Addendum #	02	Date Issued	03/31/2025
Project Name Job #	SWN 0509, Waneta Hall Renovate Restrooms	OSE # R0325--15X	EAPC #20256780
Bid Date Time	April 3, 2025		3:30pm

THIS ADDENDUM AMENDS AND BECOMES PART OF THE CONTRACT DOCUMENTS FOR EAPC PROJECT 20246780 DATED 03/13/2025, RESPECTIVELY. EACH BIDDER SHALL ACKNOWLEDGE RECEIPT OF THIS ADDENDUM BY MARKING THE ADDENDUM NUMBER AND DATE ON THE BID FORM.

DRAWING TITLE
FINISH PLAN - SECOND FLOOR

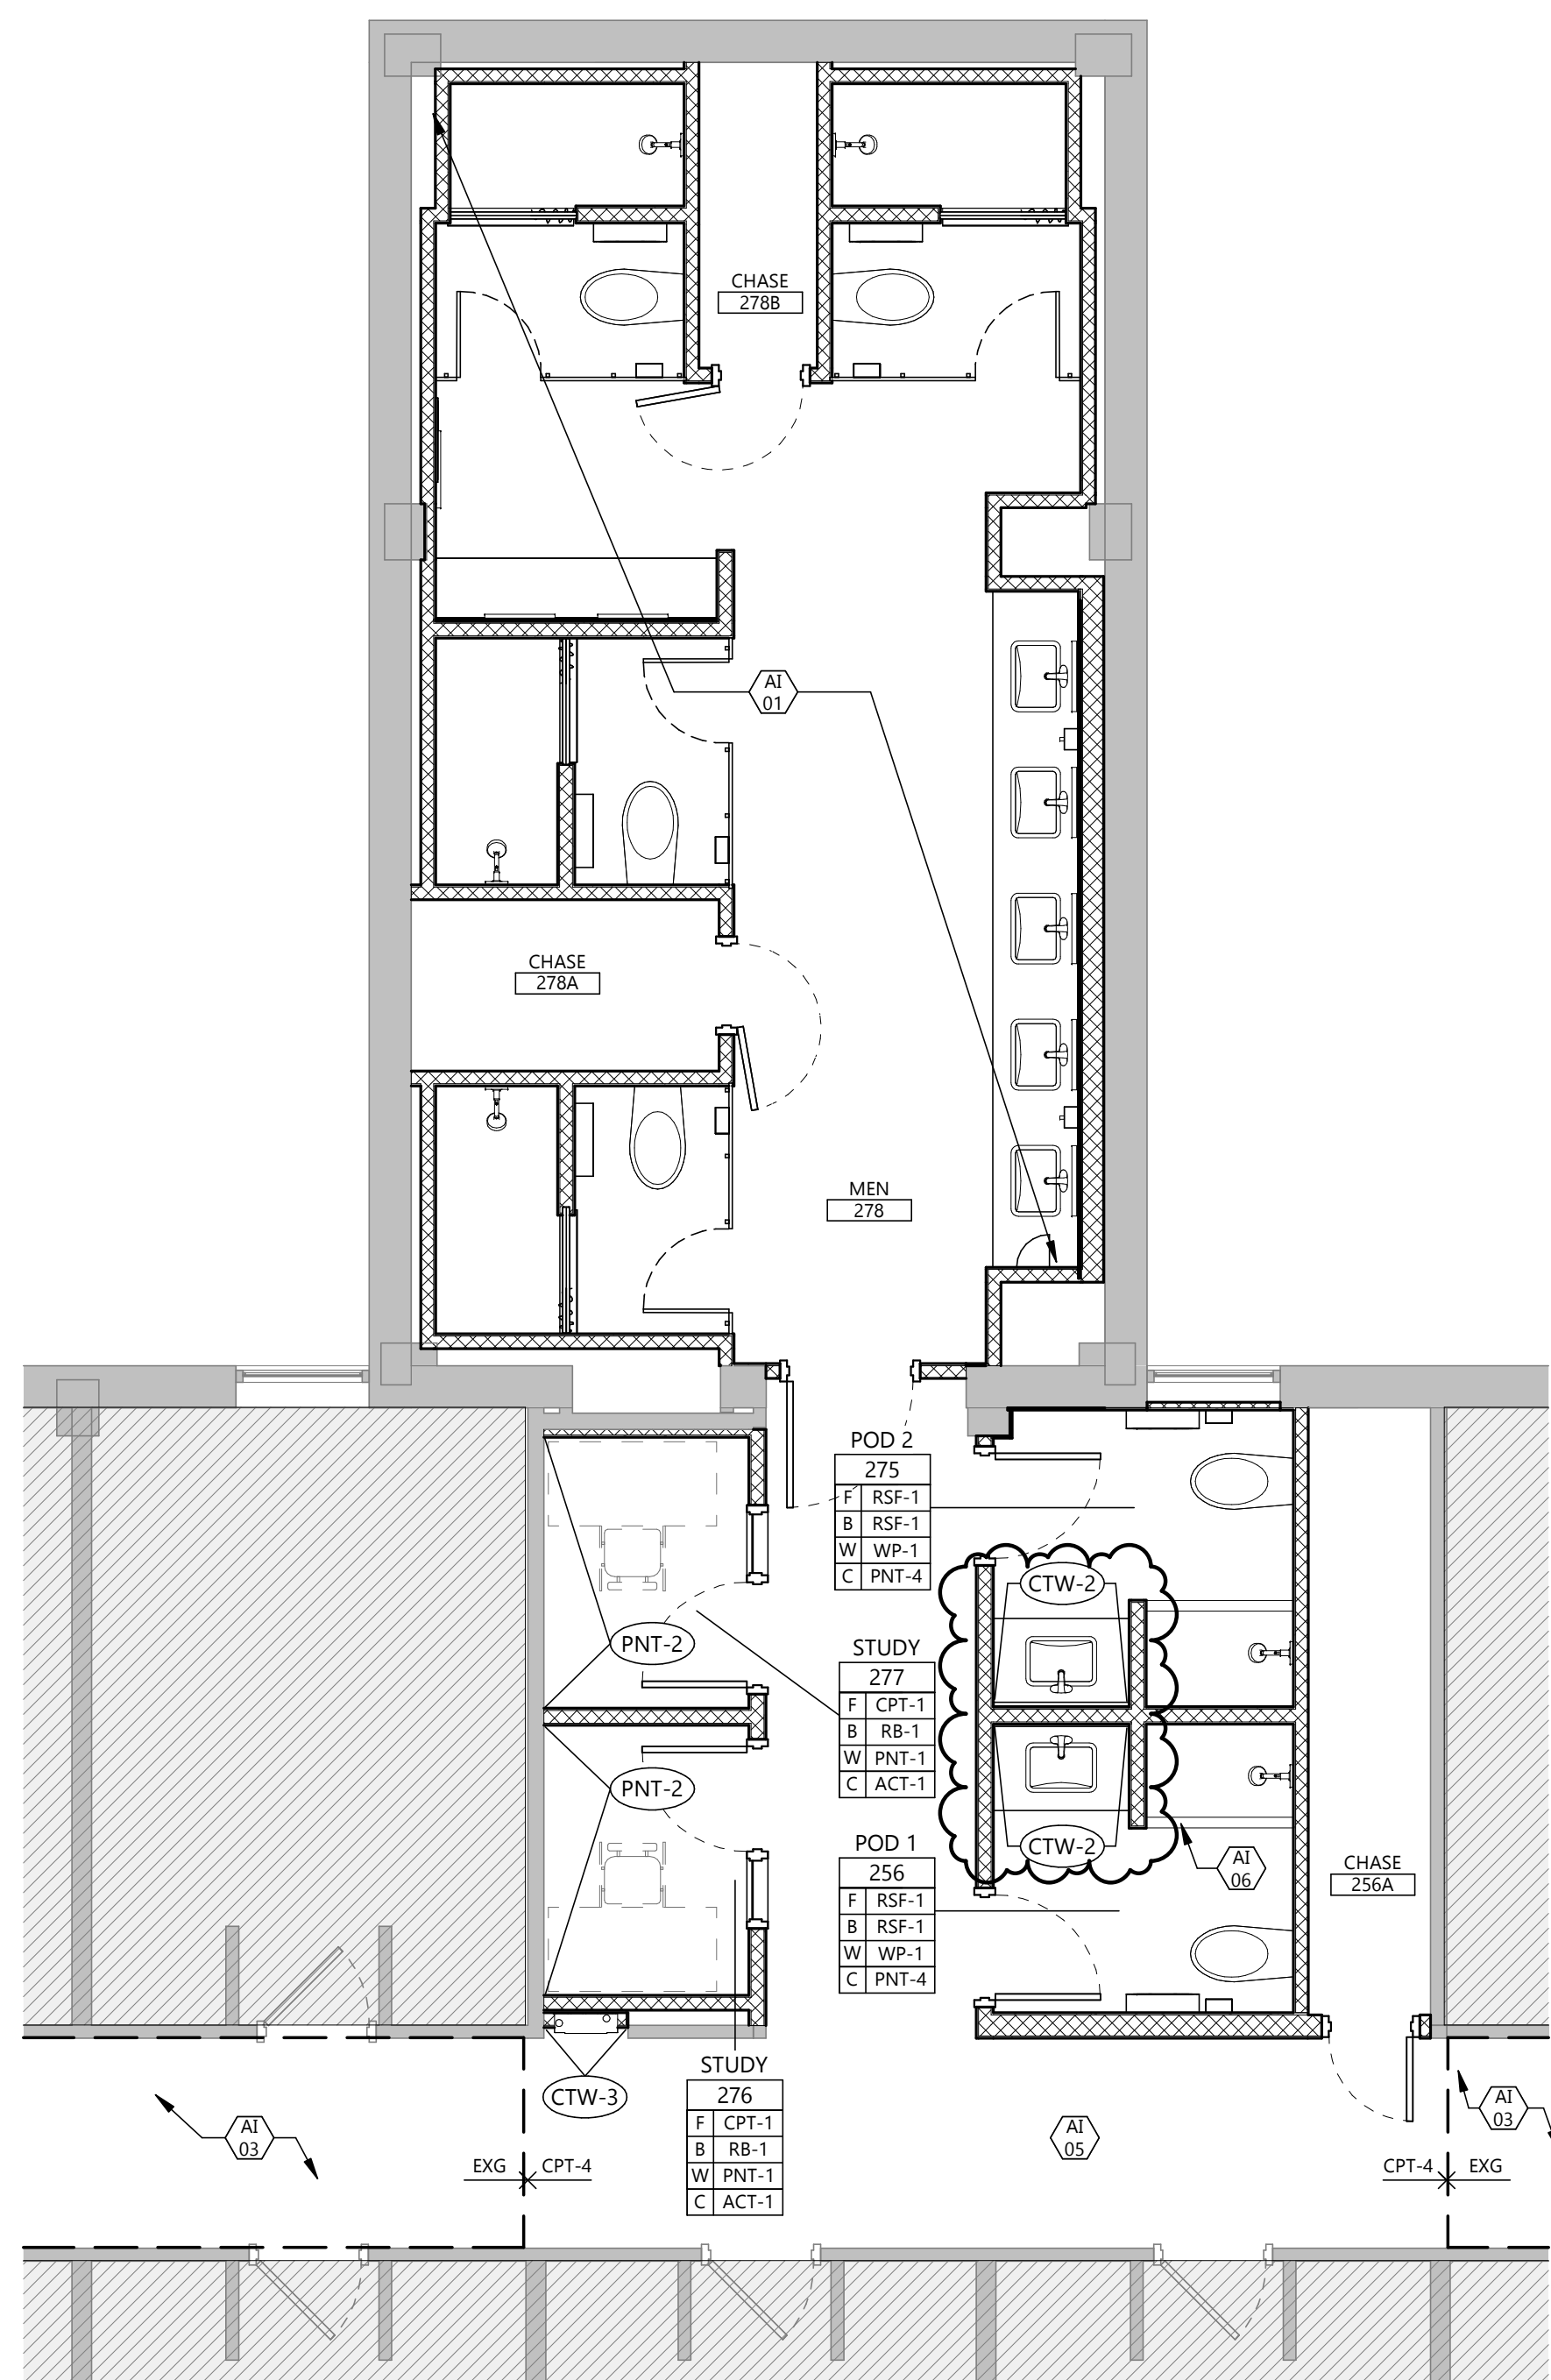
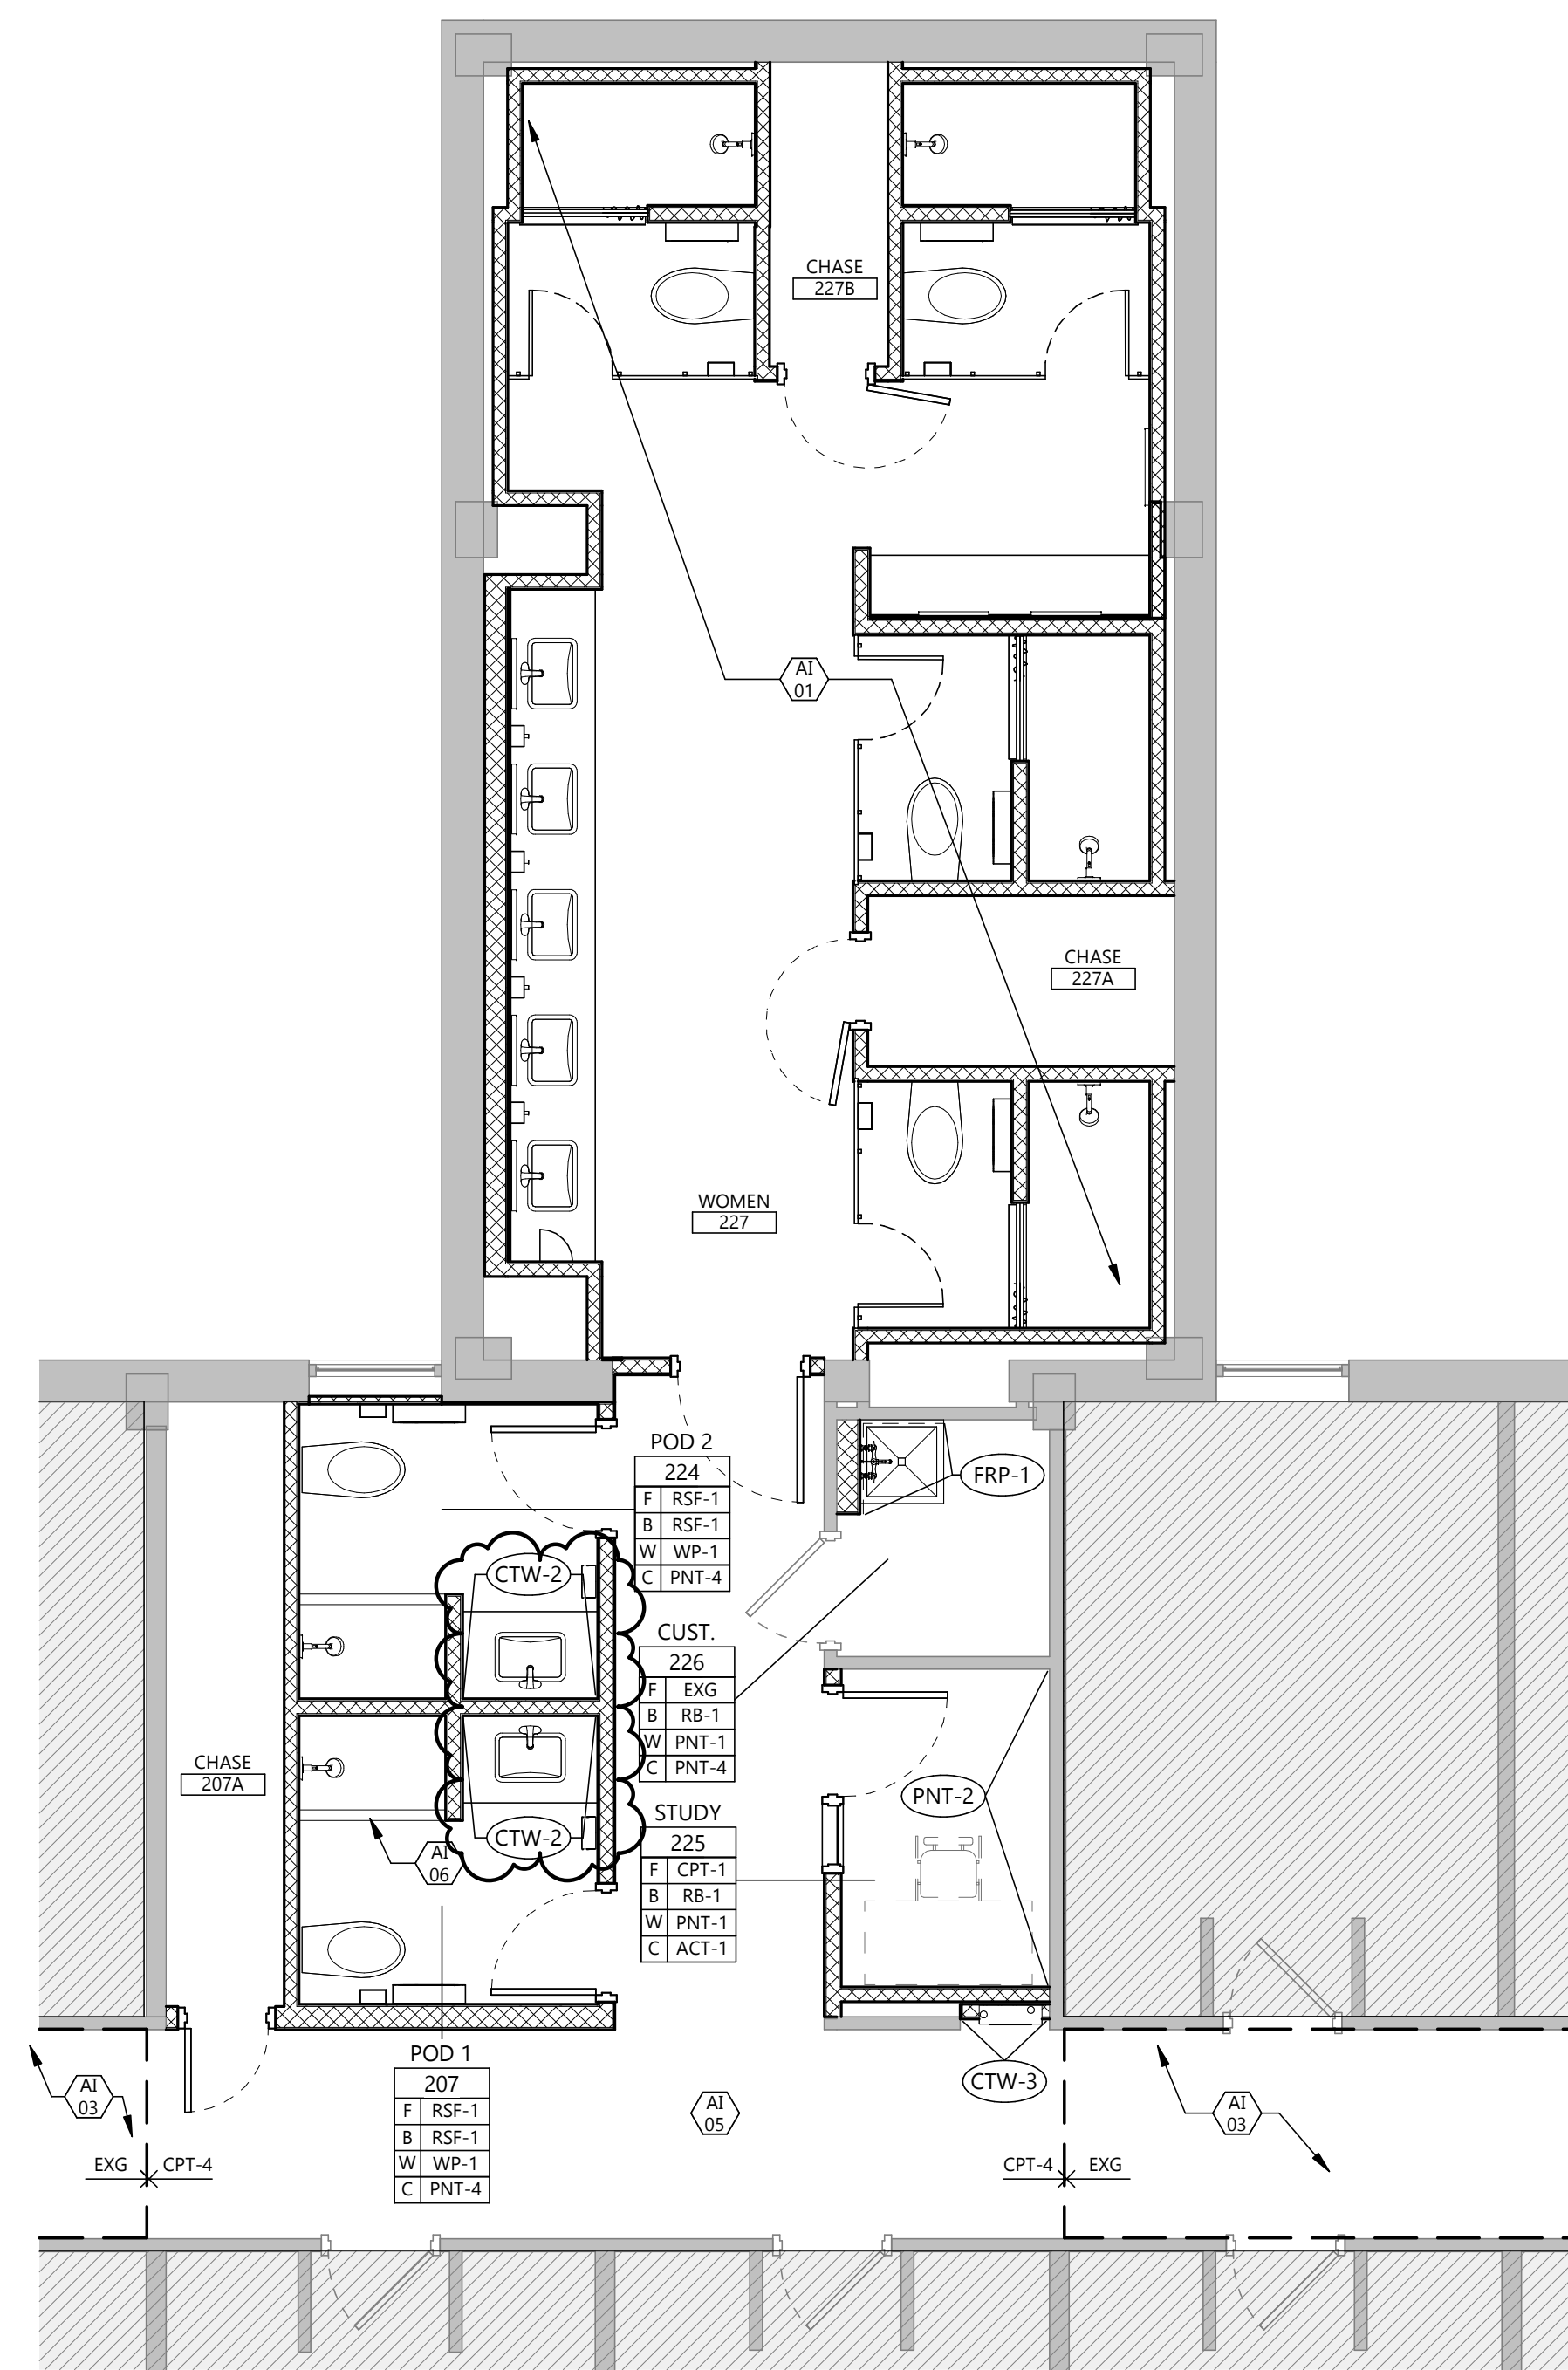
- A902 REVERSE Keynote AI 03.
CLARIFY paint finishes at General Finish Notes 5,17,19, and 22.
- A904 REVERSE Keynote AE 02 to AE 55.
ADD Keynote AE 55 and REVERSE AI 04 in Keynote Legend.
REVERSE finish transitions and CLARIFY room numbers at detail 1/A904.
CLARIFY paint finishes at General Finish Notes 5,17,19, and 22.
